Change Description

Product Name:	EZ-BLE PProC Module
FCC ID:	WAP2011
IC Model No.:	CYBLE-012011-00/ CYBLE-212019-00/ CYBLE-212020-01
IC :	7922A-2011

CYBLE-212019-00
	CYBLE-212020-01

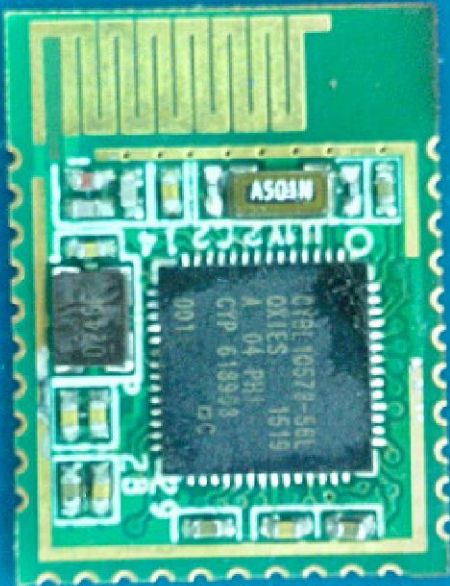
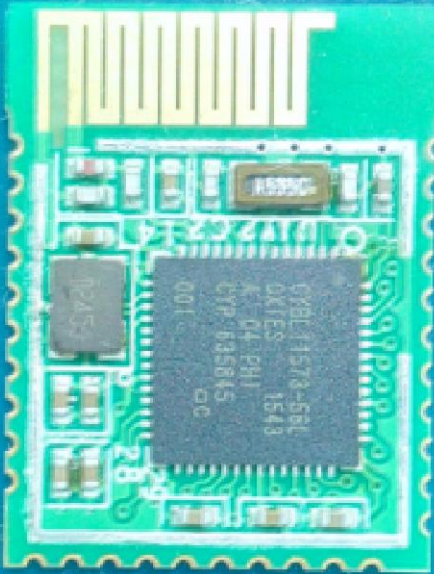
Modules CYBLE-012011-00, CYBLE-212019-00 AND CYBLE-212020-01 have the same PCB, periphery parts and the encapsulation of the main chip.

The RF character of these modules are the same.

Below is detailed difference between BLE4.2 and BLE4.1 chip:

- 1) 4.2 has improved security compared to 4.1 – this is ECDH on top of AES-128 in 4.2, whereas 4.1 is AES-128 only. This allows for transfer without having to exchange keys over the air. ECDH essentially embeds the key changes into the data transfer.
- 2) 4.2 has improved privacy compared to 4.1 – MAC address changes after a period of time for the BLE device. This is the same in 4.1 and 4.2, however in 4.2 the MAC address changing is happening in the link layer (where it was done in the GATT layer in 4.1). This change makes it so that you can use the feature without waking the entire system/stack.
- 3) Increase the maximum packet length from 37 bytes to 255 bytes.
